Interpretation of Research on Fuel Fragmentation, Relocation, and Dispersal at High Burnup

Date Published: December 2021

Prototypicality and Representativeness of Empirical Database	20
Discussion of Consequences and Consequence Modeling	21
Limitations of the Empirical Database	22
Summary and Conclusions	23
Acknowledgments	24
References	25
Appendix A: A Model for Predicting Dispersal	A-1
Appendix B: Summary of Peer Review Comments and Resolution	B-1

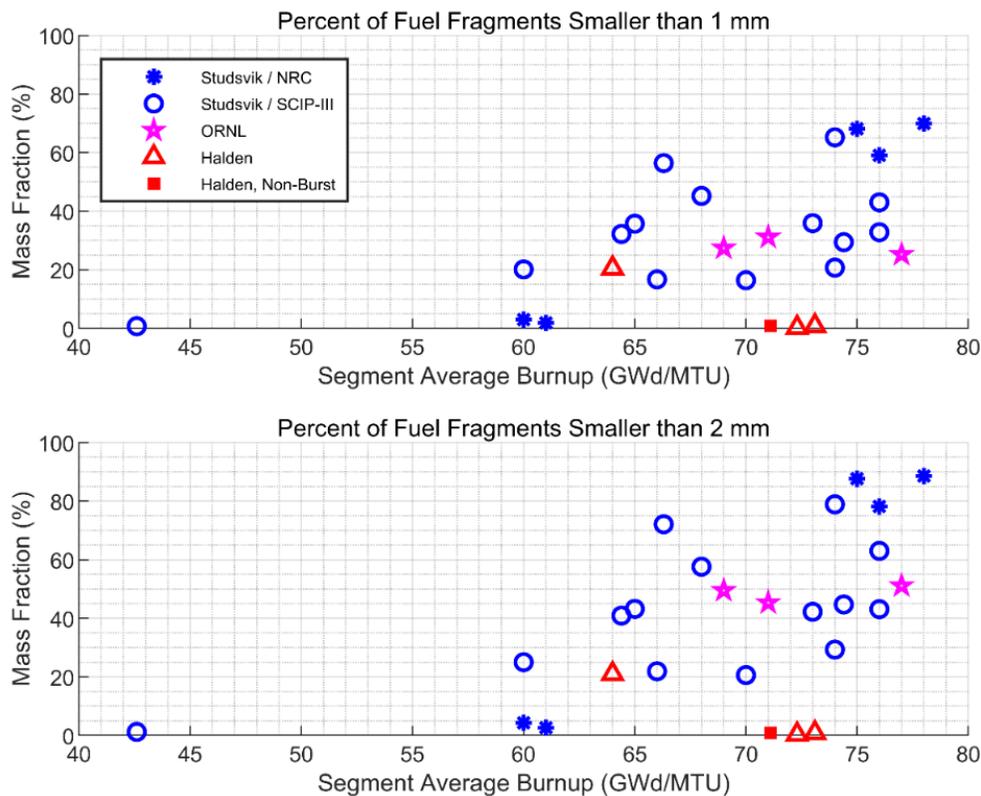
- Reviewers suggested that the RIL specify the basis for examining the mass of fuel fragments smaller than 1 and 2 millimeters. Text was added to explain that these size categories were considered for their indication of trends with burnup.

Figure 9. Posttest gamma scans of IFA-650.9, a high-burnup PWR fuel rod subjected to a LOCA simulation at the Halden reactor (NRC, 2012).

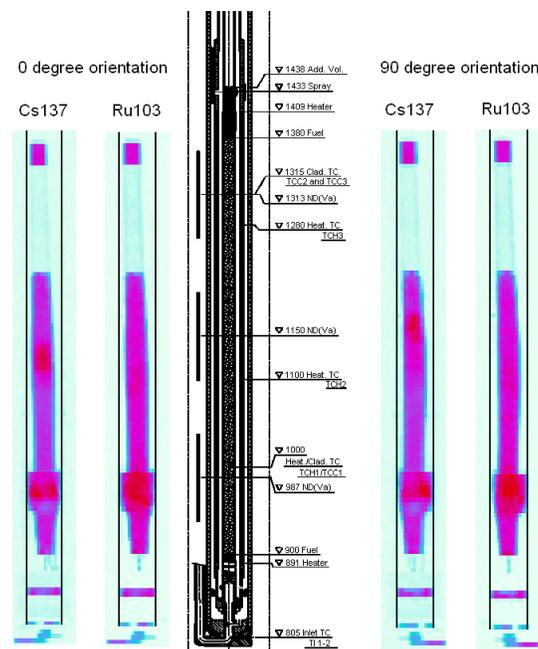
- Reviewers suggested removing references to low and high gap conductivity for cases without and with fuel relocation in Figure 9. This comment was not accepted.

Figure 12. Average packing fraction in the lower portion of the balloon in the SCIP III tests (Magnusson, et al., 2020).

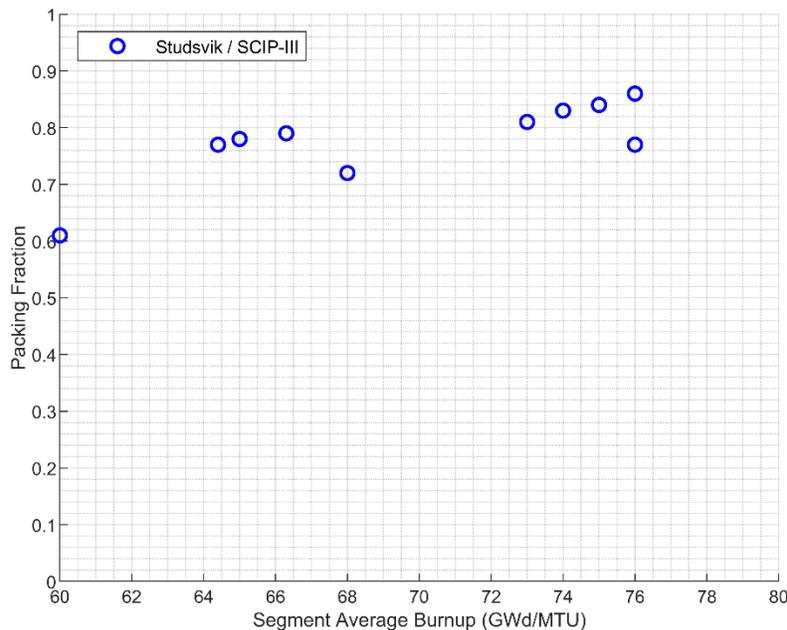
- Reviewers asked for clarification of how the axial distribution of packing fraction in Figure 12 relates to single values of the packing fraction cited for the various tests. This comment was accepted, and discussion was added about the particular test shown in Figure 12.
